FINAL DRAFT MINUTES

April 18, 2024, Standards Committee Meeting

Standard Drawing:
E 609-RCBA-04

REINFORCED CONCRETE BRIDGE APPROACH SECTION,
PAVEMENT LEDGE, AND BAR BENDING DETAILS

E 609-RCBA-04 REINFORCED CONCRETE BRIDGE APPROACH SECTION, PAVEMENT LEDGE, AND BAR BENDING DETAILS (with shown markups)

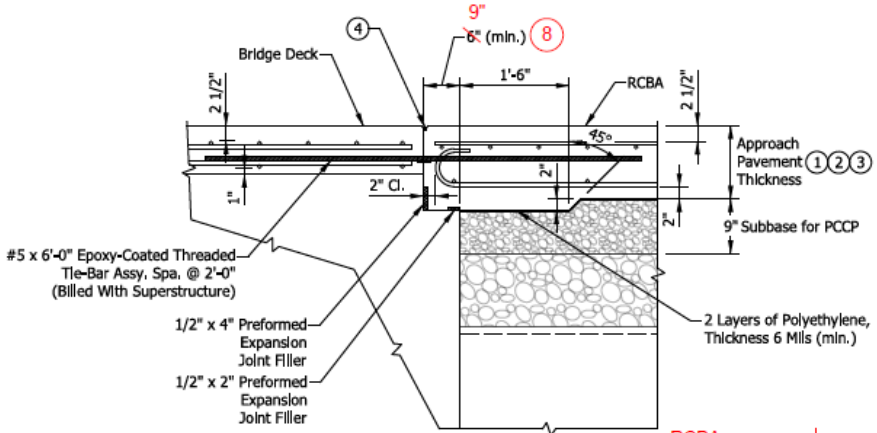
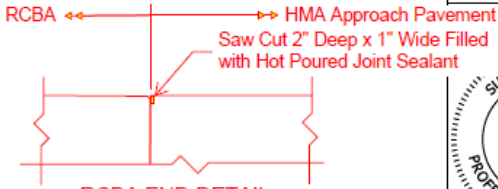
PROBLEM(S) ENCOUNTERED: The current standard pavement ledge width of 6” can create vulnerabilities to future settlement of the RCBA relative to the bridge deck. The concrete-to-concrete bearing width is only 3 ½” after subtracting the widths of the PEJF material, so even a relatively small amount of deterioration or poor concrete consolidation can result in insufficient bearing capacity, which can lead to settlement. It has also been observed that the interface between the end of the RCBA and adjoining HMA pavement, when no terminal joint is required, can develop a slight separation that can allow water infiltration.

PROPOSED SOLUTION: Increase the standard pavement ledge width from 6” to 9” and add a detail to seal the interface between the end of the RCBA and adjoining HMA pavement when no terminal joint is required.

This item was introduced and presented by Mr. White, who stated that the current standard pavement ledge width of 6 in. can create vulnerabilities to future settlement of the RCBA relative to the bridge deck. The concrete-to-concrete bearing width is only 3 ½ in. after subtracting the widths of the PEJF material, so even a relatively small amount of deterioration or poor concrete consolidation can result in insufficient bearing capacity, which can lead to settlement. It has also been observed that the interface between the end of the RCBA and adjoining HMA pavement, when no terminal joint is required, can develop a slight separation that can allow water infiltration.

Mr. White proposed to increase the standard pavement ledge width from 6 in. to 9 in. and add a detail to seal the interface between the end of the RCBA and adjoining HMA pavement when no terminal joint is required.

Mr. Reilman asked how the joint between the RCBA and the adjoining HMA will be filled. Mr. White said it will be Hot Poured Joint Sealant as shown on the drawing. Mr. White said a RPD may be helpful until the revised standard drawing is effective.
